JRPP REPORT No. 2012SYE084

DA 2012/311

52 Mowbray Place & 72, 74 & 76 Eastern Valley Way, Willoughby.

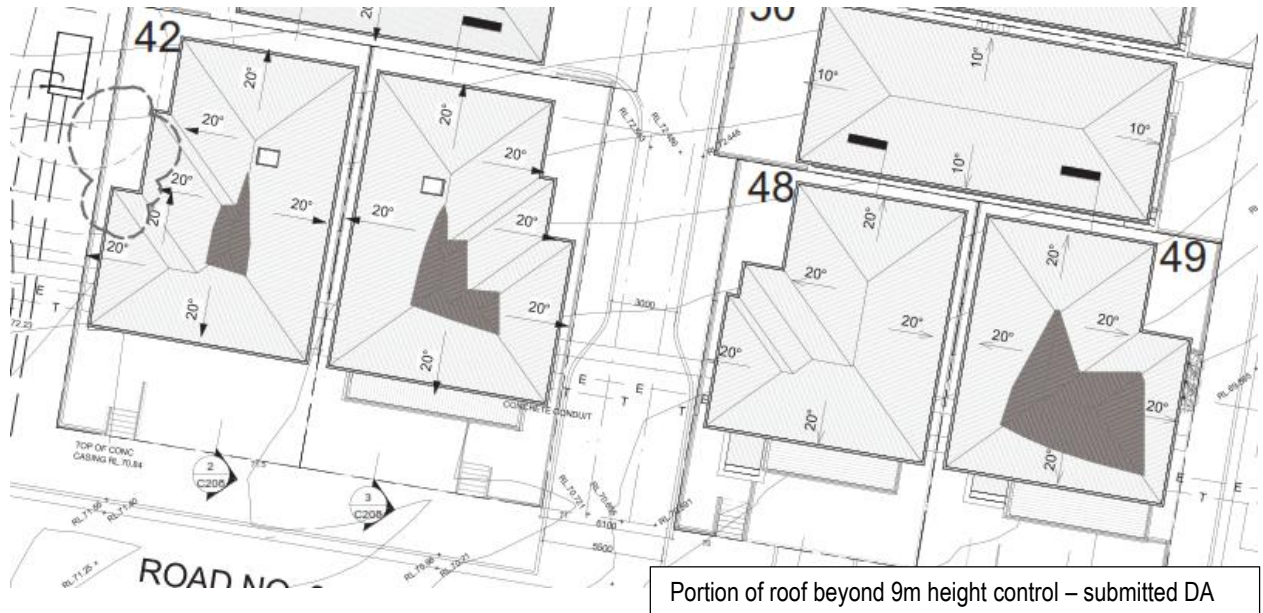
1.9 The design of the southern facades to these houses includes the main façade setback a minimum of 3m from the front boundary. The balconies with their framed supporting elements and roofs create the main façade of these dwellings. This is consistent with the façade design established across the site at Kiah development. For these houses the third storey is setback approximately 2m from the main façade alignment, such that it is setback in excess of 5m from the street frontage. The design provides an upper level setback greater than the 1m required by the design guidelines, to achieve a greater stepped effect and a modulated and articulated building form and streetscape.

- 1.10 These lots are significantly constrained by the existing fibre optic cable that runs along the frontage of the sites. However, these areas are within the maximum height limit.
- 1.11 As shown in the following extract from Drawing C107A Lots 42 & 47 result in a marginal variation to the height control required by Draft Willoughby Local Environmental Plan of 9 metres. The non-compliance is toward the apex of the roof and will have a marginal impact on the bulk and scale of the dwellings.

- 1.12 It is therefore considered that the proposed form and design of the dwellings on lots 42, 47 & 48 is appropriate and it is requested that this part of the condition be deleted.

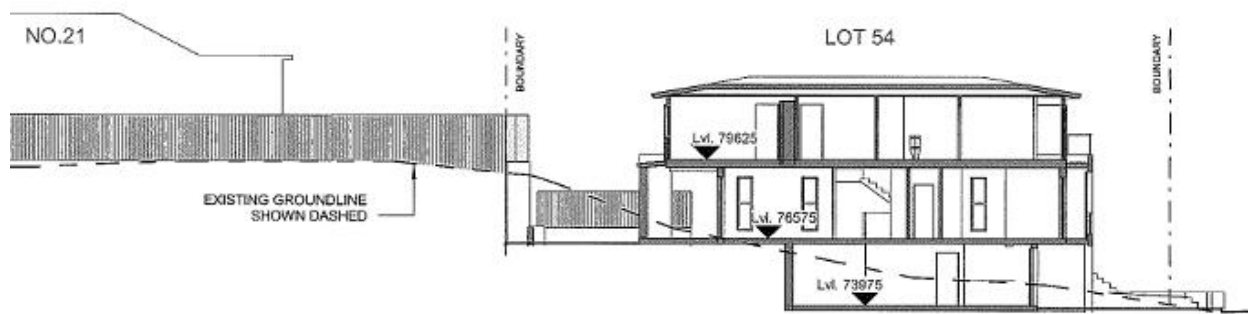
- 1.20 As submitted, the plans propose a rear setback that varies between 5.6 – 6.6 metres. The adjacent dwelling at 21 Windsor Road is setback an additional 9 metres from the common boundary. The position of the dwelling is considered highly appropriate and providing an additional 400mm setback at the northern end will not result in a tangible impact. The windows to Lot 54 will be restricted from overlooking due to the relationship in levels and the 1.8 metre high boundary fence.
- 1.21 It is considered that the combination of the relationships in levels, setback between the dwellings (min 14.6 metres) and the position of the boundary fence provide appropriate privacy between the dwellings as shown in the following section.

- 1.22 It is therefore requested that Condition 2f be deleted.

~~f) The rear setback of the upper level of the dwelling on Lot 54 should be no less than 6 metres.~~
